Sundry Print Report

Well Name: BLANCO WASH Well Location: T24N / R9W / SEC 2 /

Type of Submission: Notice of Intent Type of Action: Plug and Abandonment

CONDITIONS OF APPROVAL

Planned P & A Schematic

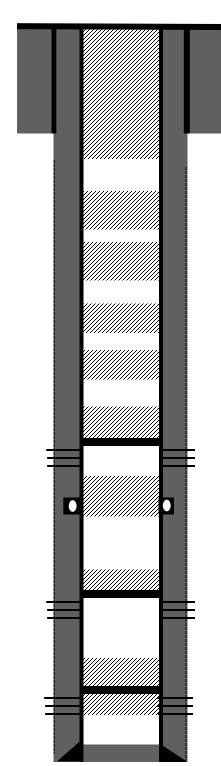
Remarks: Adjust plug V to cover BLM-picked Cliffhouse Formation. Adjust plug VI to adjust BLM-picked Lower Chacra. Adjust Plug VII to cover BLM-picked Fruitland/Pictured Cliffs.

- a. Adjust Plug #5 (Mesaverde) to cover BLM Cliffhouse formation top pick @ 2990'. Estimated minimum 12 Sx Cement (2890' 3040').
 - b. Adjust Plug #6 (Chacra) to cover BLM Lower Chacra formation top pick @ 2485'. Estimated minimum 12 Sx Cement (2385' 2535').

- c. Adjust Plug #7 (Fruitland/Picture Cliffs) top to cover BLM Picture Cliffs and Fruitland formation top picks at 1679' and 1310', respectively. Estimated minimum 41 sx Cement (1210' 1729')
